# Service Bulletin

Bulletin 2003-10-ABDE

## SUBJECT: UHC Service Notes

## RTD Circuit Repair:

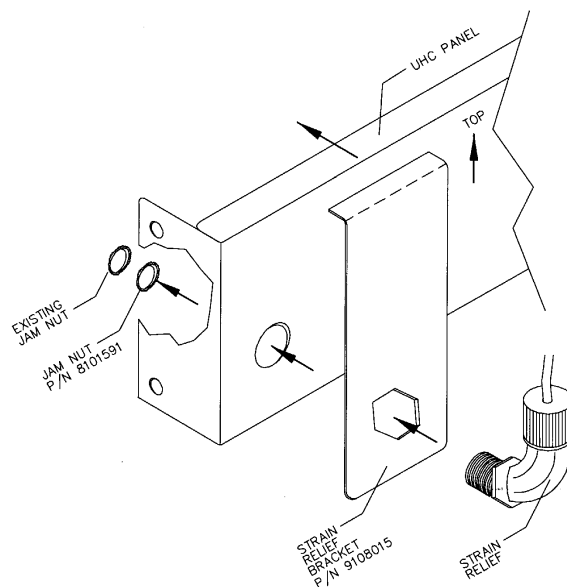
The following error messages in the display of a Universal Holding Cabinet (UHC) usually indicate a poor connection between the wire and terminal on the brown and red RTD wires:

Almost all terminals have been recrimped as part of prior rework programs and this has substantially reduced the incidence of the error messages above. If any of these error messages occur, remove the RTD terminals from the master control board and solder the wires to the terminals. **Do not replace components before soldering terminals.**

**Never change a display driver board to correct the error messages above.** The RTD circuits are totally independent of the display drivers.
